## Section 96 (2) Report to Sydney West Joint Regional Planning Panel

<b>JRPP No.</b>	2016SYW064 DA
<b>DA No:</b>	MOD-16-00080
<b>Proposed Development:</b>	Section 96 (2) to JRPP-14-1915 that approved 6 x 4 storey residential flat buildings.
<b>Development Type:</b>	Capital Investment Value > \$20 million
<b>Lodgement Date:</b>	10 March 2016
<b>Land/Address:</b>	Lot 205 DP 660230 822 Windsor Road Rouse Hill
<b>Land Zoning:</b>	R3 Medium Density Residential SP2 Infrastructure (Classified Road)
<b>Revised Capital Investment Value of Development:</b>	\$65,449,892
<b>Applicant:</b>	Mayrin Rouse Hill DM Pty Ltd
<b>Landowner:</b>	Mayrin One Pty Ltd ATF Mayrin One Trust
<b>Report Author:</b>	Melissa Parnis, Assistant Team Leader Projects
<b>Instructing Officers:</b>	Judith Portelli, Manager Development Assessment Glennys James, Director Design and Development
<b>Date Submitted to JRPP:</b>	29 July 2016

## ASSESSMENT REPORT

Figure 1: Height variation for Stage 1- (offsets clouded)

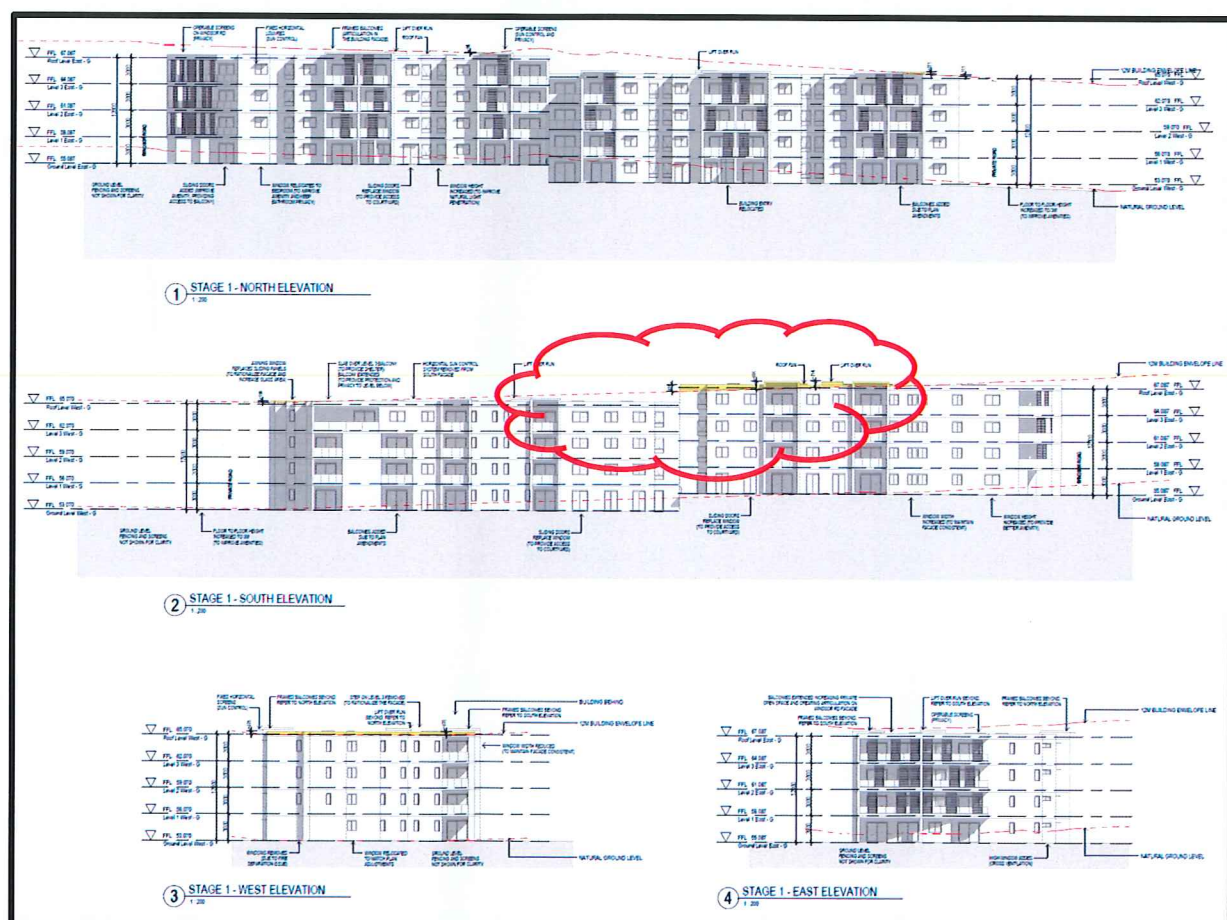
- 7.2 The maximum height limit on the site is 12 m under the Growth Centres SEPP. The maximum building height proposed by the revised design is 12.9 m, exceeding the maximum permissible building height by 909 mm. The variation is a result in modifications to the floor to floor height, increasing the floor to floor heights from 2.85 m to 3.0 m to provide for a revised construction method and to achieve the required 2.7 m floor to ceiling heights under the Residential Flat Design Code. The following images identify in yellow the height exceedance, with building height offset areas clouded.

- 7.3 The variation to building height by up to 909 mm is considered minor as the portions of the building over the height limit include parapet, plant and equipment and lift overrun but no residential units. The topography of the land also results in elements of the building being more than 1.5 m below the maximum height limit. Therefore, the development is not considered to be achieving additional floor space and still presents as a 4 storey residential flat building, meeting the objectives of the development standard.

- 7.4 The proposed exception to the development standard is considered satisfactory as the variation does not result in any additional amenity impact on adjoining properties in regards to overshadowing or privacy impacts. Further, the redesign of the development has improved the amenity for future residents and the overall presentation of the development to the streetscape. Therefore, based on its merits, the minor variation to the maximum building height is considered satisfactory.
